Subject: Clarrie Hall Dam Wall Raising Environmental Impact Statement (EIS) (SSI-65020460)

Thank you for your referral in the Major Projects Planning Portal dated 26 September 2024 seeking advice from the Biodiversity, Conservation and Science Group (BCS) of the NSW Department of Climate Change, Energy, the Environment and Water (DCCEEW) on the EIS for the Clarrie Hall Dam Wall Raising project.

ATTACHMENT C Detailed comments for Clarrie Hall Dam Raising Environmental Impact Statement (SSI-65020460)

Figure 1: SHR no. 01487 curtilage (solid light green) in relation to current boundary of Mount Jerusalem National Park (paler green) following the 2020 revocation of 1.91 hectares from the park (SEED Map, NSW Government)

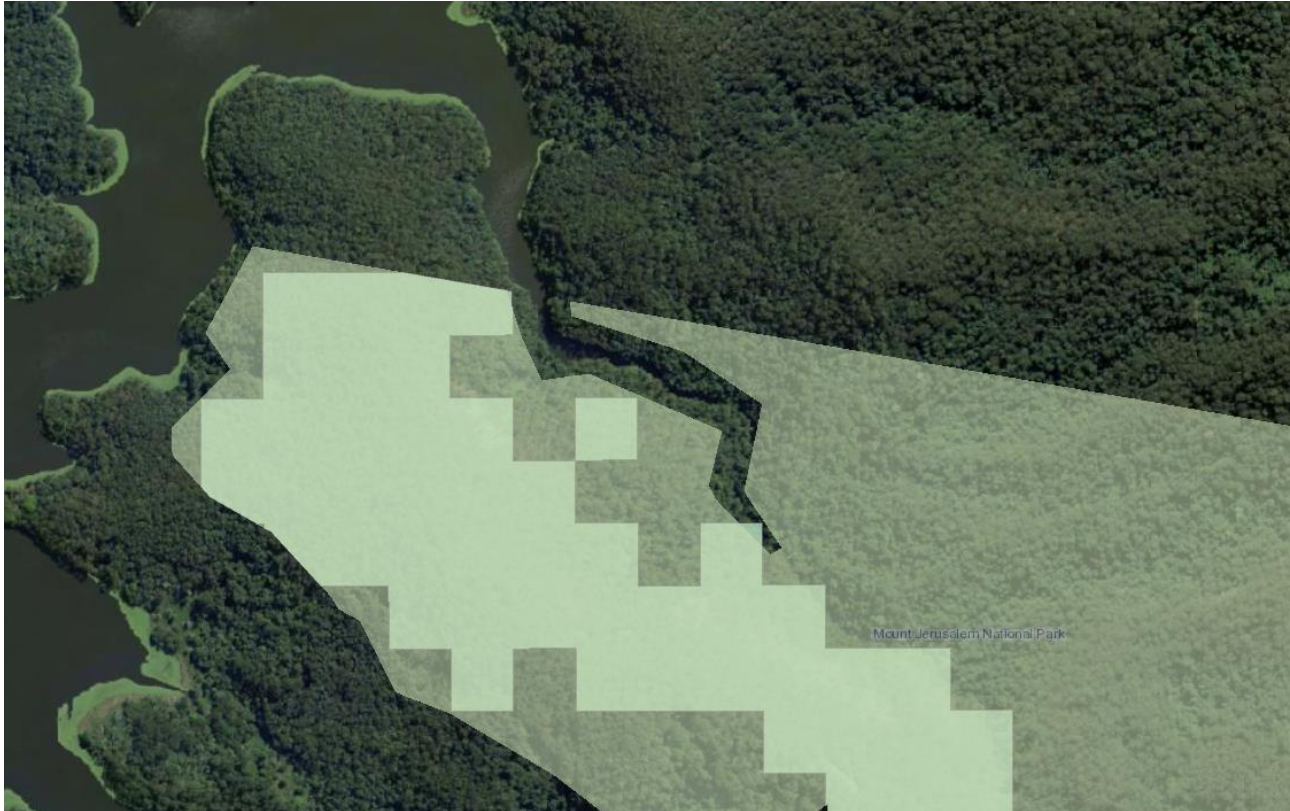
NPWS highlights that the mapping of this item's curtilage in the Historic Heritage Report (Figure 1.3, page 10) is not consistent with the mapping in the State Heritage Inventory³ or that is available on SEED⁴.

This means the EIS does not correctly identify that a small area of land revoked from Mount Jerusalem National Park to accommodate the new FSL is covered by the mapping of the item's curtilage and so the development footprint overlaps SHR no. 01487 (see Figure 1 below).

2. As part of the RTS, the proponent:
 - a. Identifies the portion of SHR no. 01487 that is no longer in Mount Jerusalem National Park and so lies within the development footprint
 - b. Assesses the potential heritage impacts of the new FSL to this section of the curtilage of SHR no. 01487.

Figure 5: Proposed rock quarry haul road options 1 (left) and 2 (right).

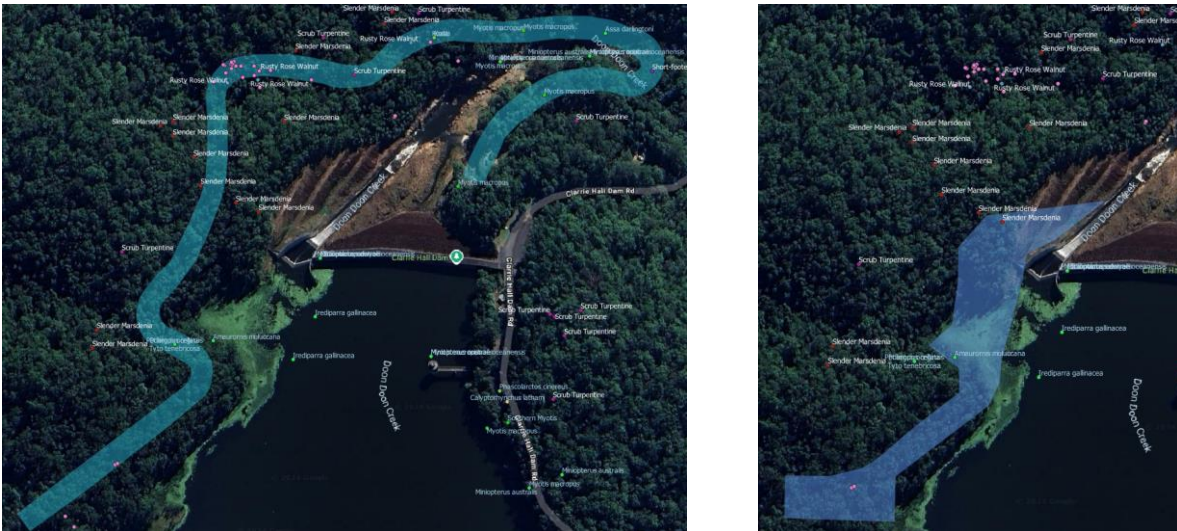
The EIS and BDAR identify two options for the proposed rock quarry haul road route (see Figure 5 below). Haul road option 1 would remove significantly more native vegetation and threatened species habitat and lead to greater long-term edge effects than option 2.

18. Haul road option 2 be adopted as part of the project design to minimise direct and indirect biodiversity impacts.

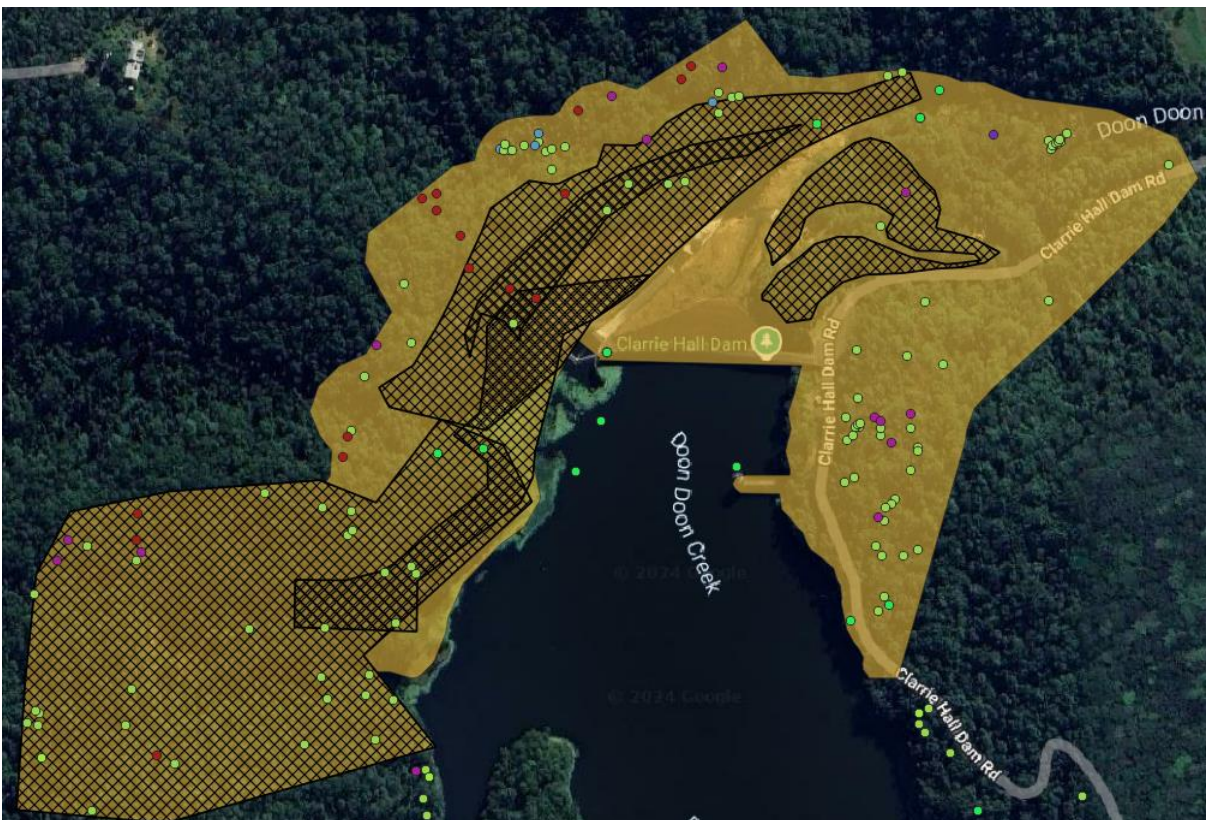
The mapped construction disturbance area around the dam wall appears to extend well beyond the various construction components of the project, particularly if the haul road option 2 is adopted (see Figure 6 below). Biodiversity credit obligations calculated in the BAM-C and presented in the BDAR have been based on a broader construction disturbance area, which indicates there may be opportunities for the proponent to further avoid biodiversity impacts by refining and confirming the actual development/clearing footprint.

19. The project development footprint around the rock quarry haul road, new spillway and realigned Clarrie Hall Dam Road be further refined and detailed in the BDAR to avoid biodiversity impacts.
